# City of Tualatin

## ARCHITECTURAL REVIEW FINDINGS AND DECISION

### \*\* APPROVAL WITH CONDITIONS \*\*

Case #: AR-17-0009  
 Project: Air Liquide Gas Depot  
 Location: [10500 SW Tualatin-Sherwood Road](#)  
 (Tax Lot: 2S126B000105)  
 Applicant: Matt Oullette, 131 Third Ave. Longview, Washington 98632  
 Project Contact: Eric Lanciault 3200 SE 164<sup>th</sup> Ave., suite 302 Vancouver, WA 98683

PROJECT NO: 170359	DRAWING NO: <b>C451</b>
SCALE: AS NOTED

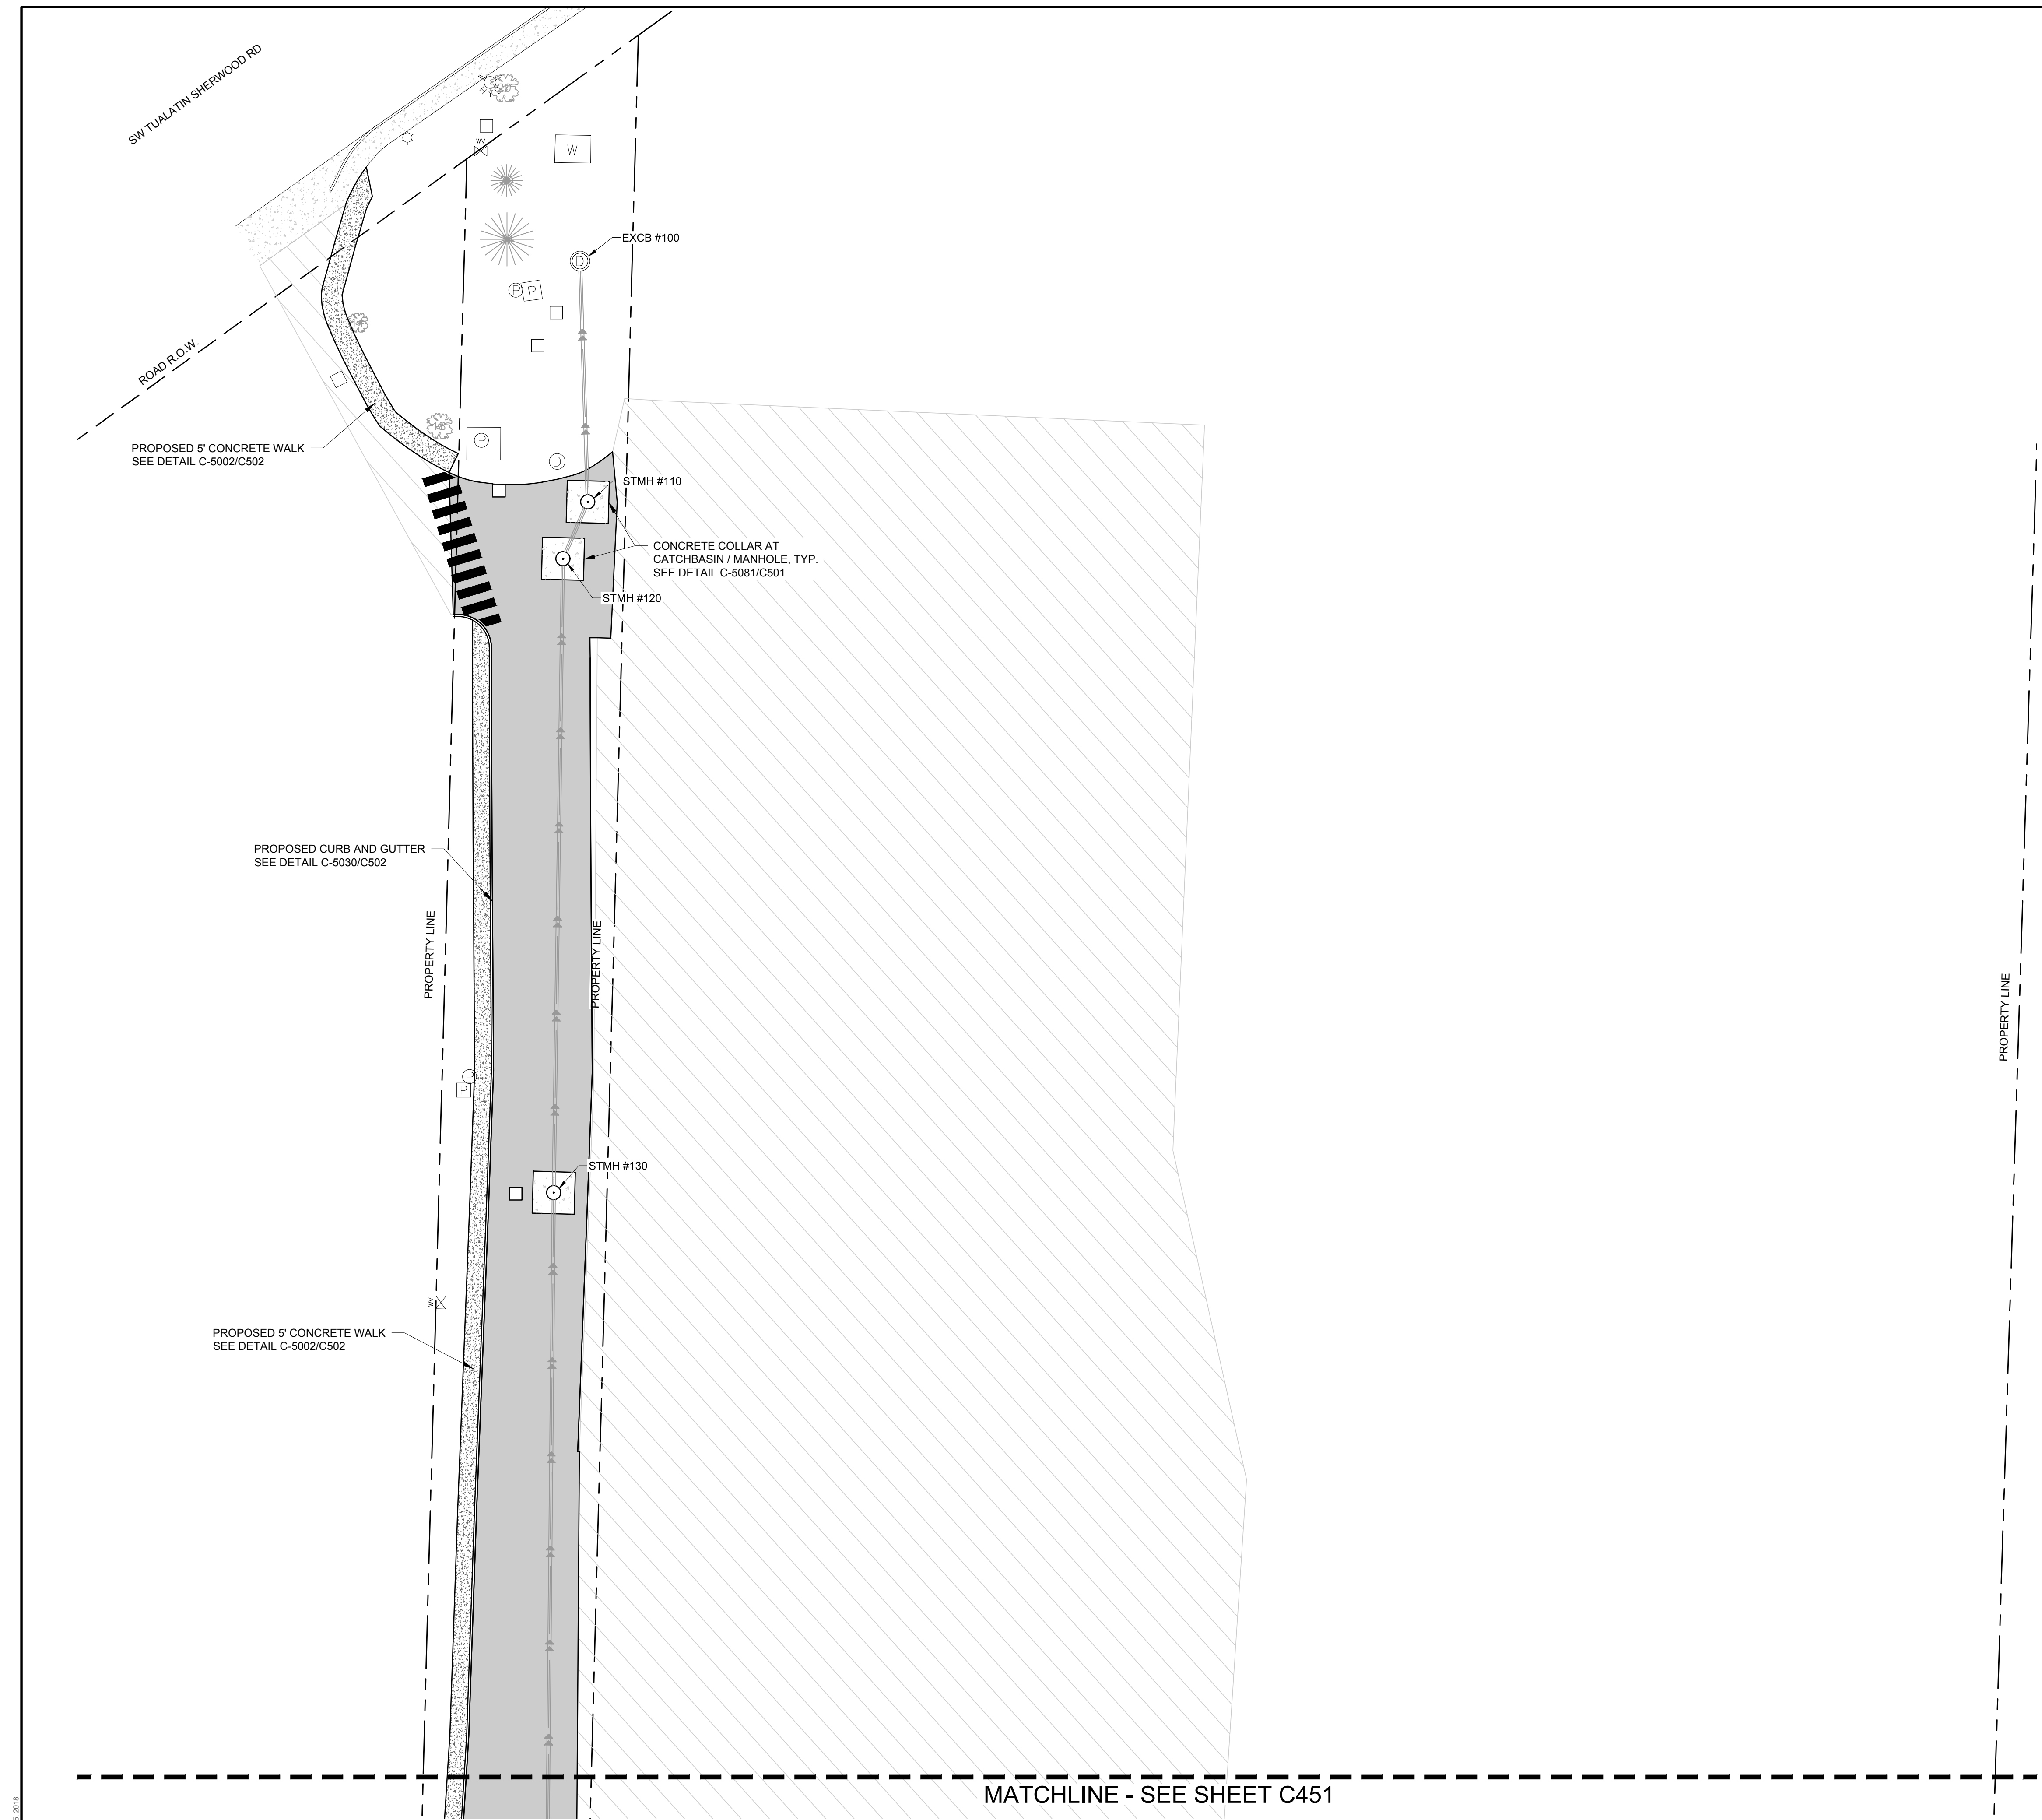
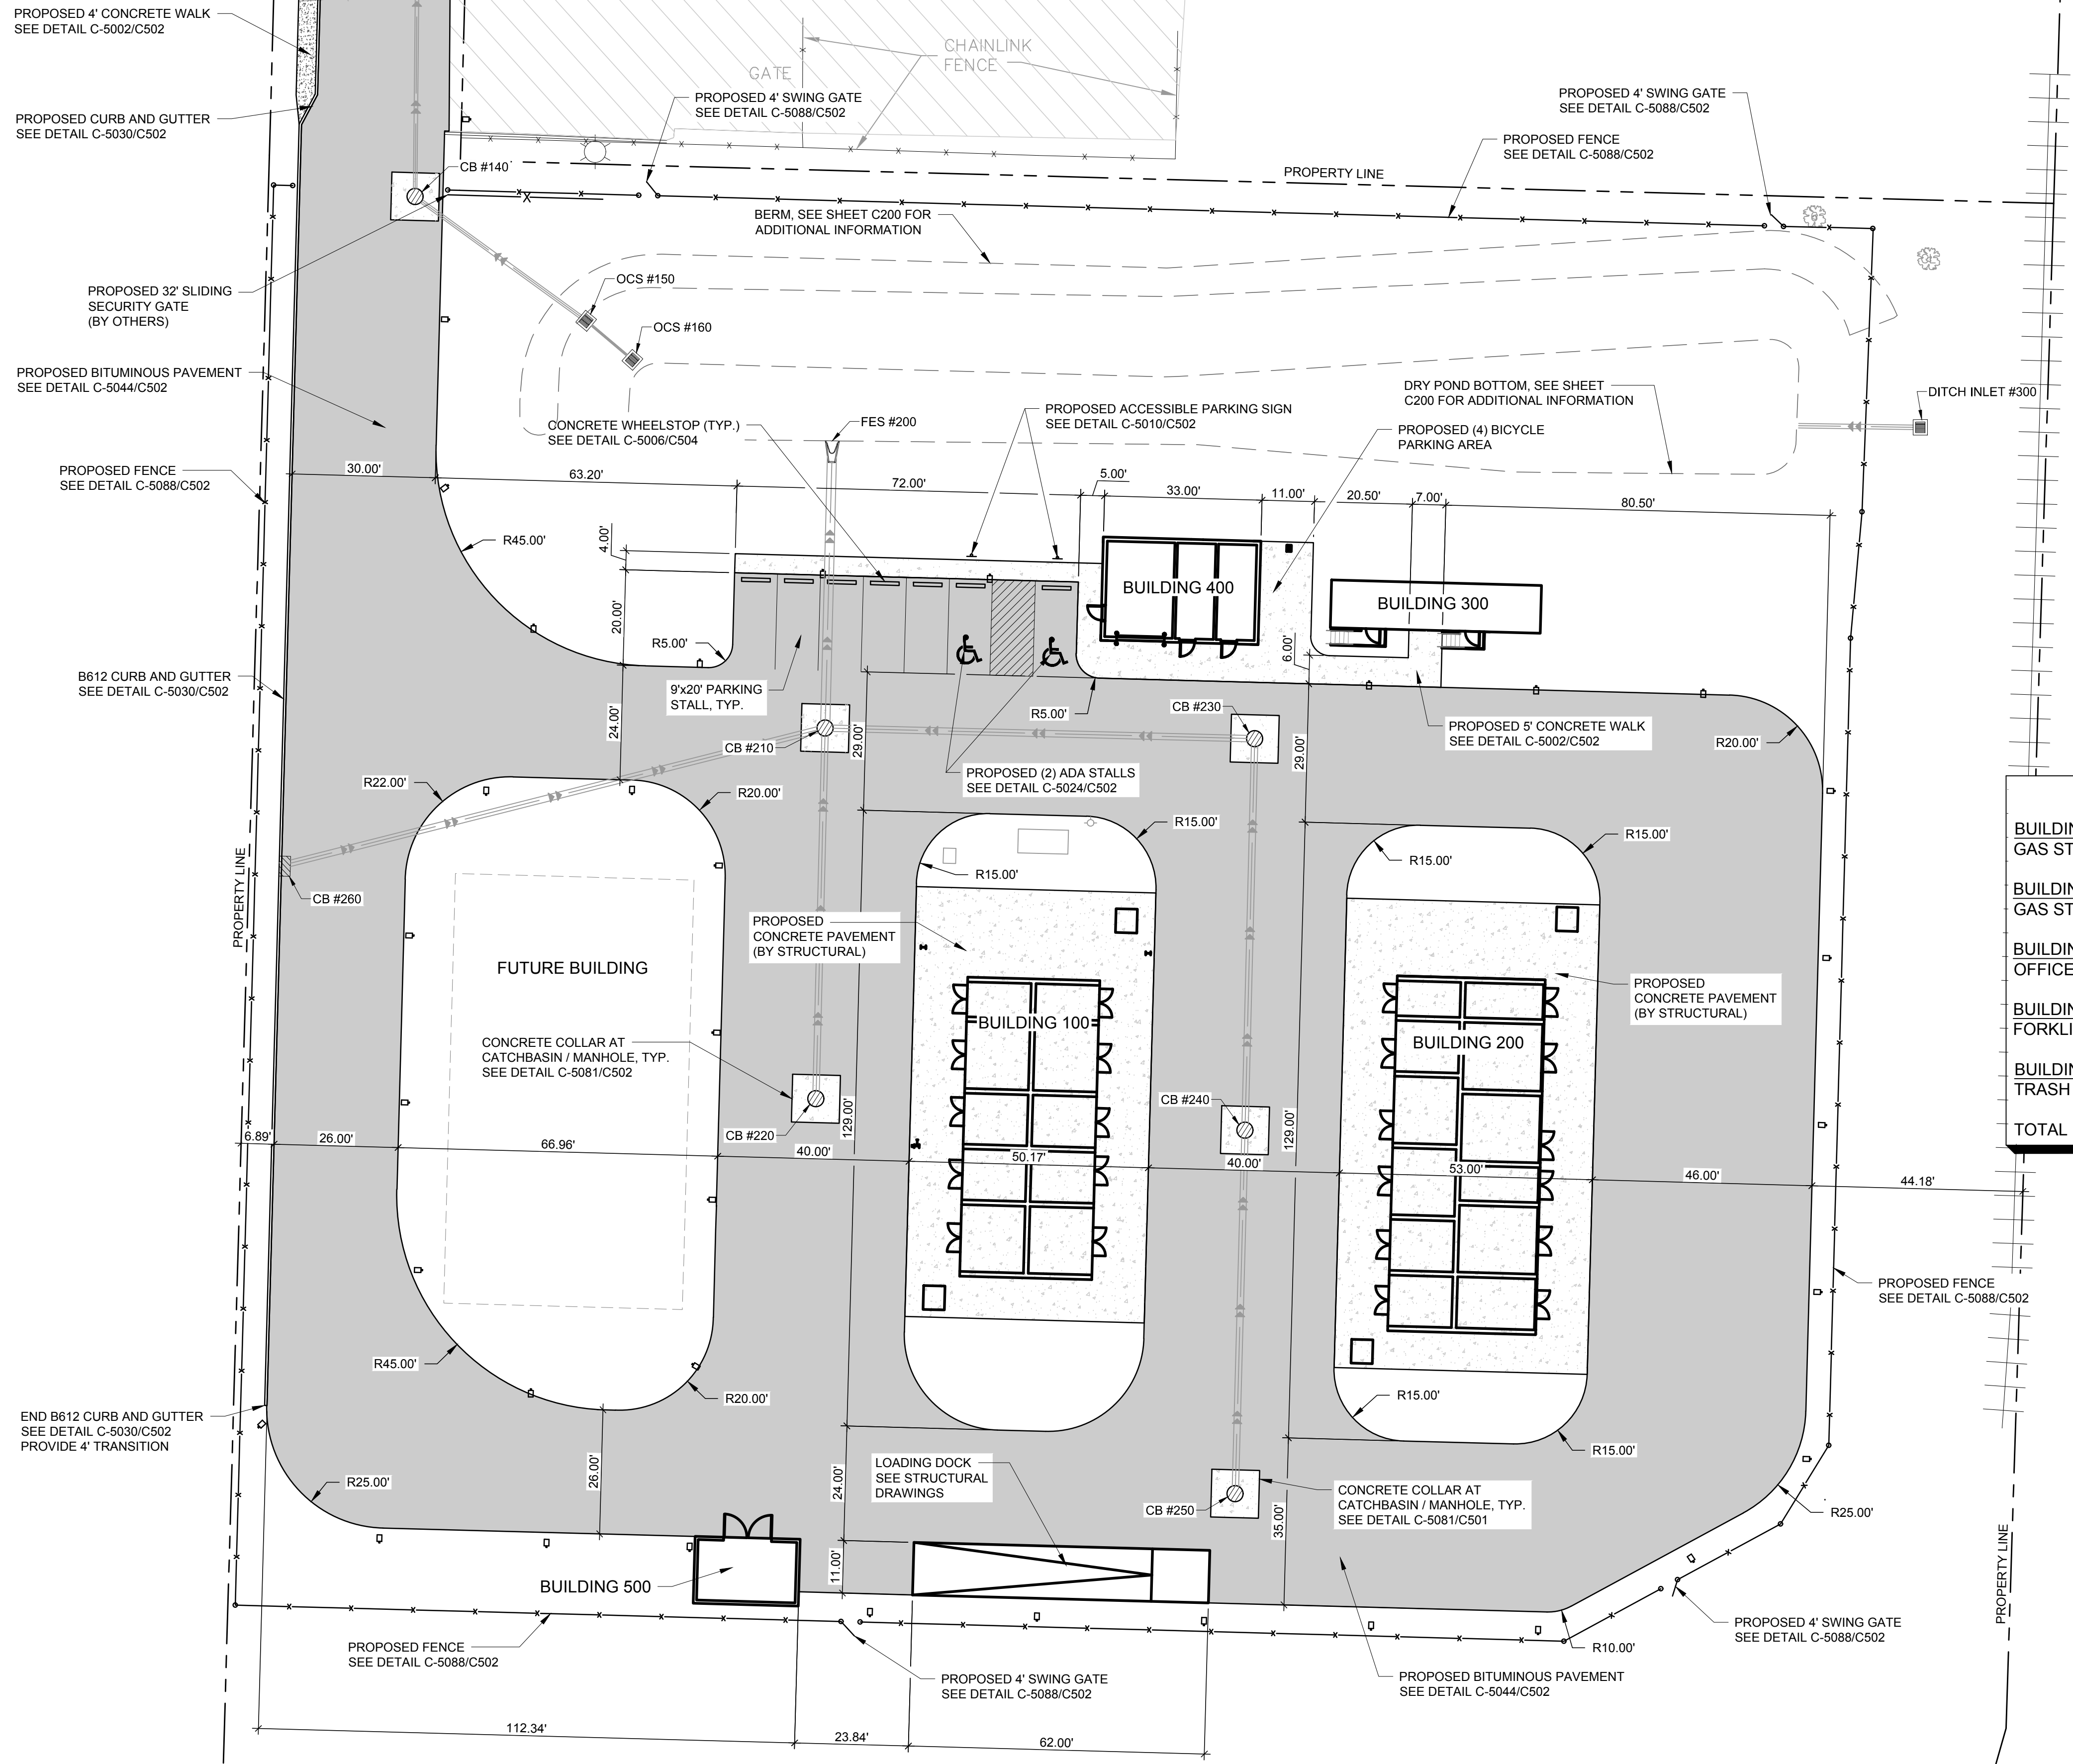
*Sheet C451 illustrates that parking stalls are 9 x 20 ft and two way access aisles are 24 ft wide at narrowest point. Figure 73-1 requires a stall depth of 18.5 ft for 90 degree parking. The standard is met.*

*Staff notes that sheet C451 shows wheel stops at all parking stalls. This standard has been met.*
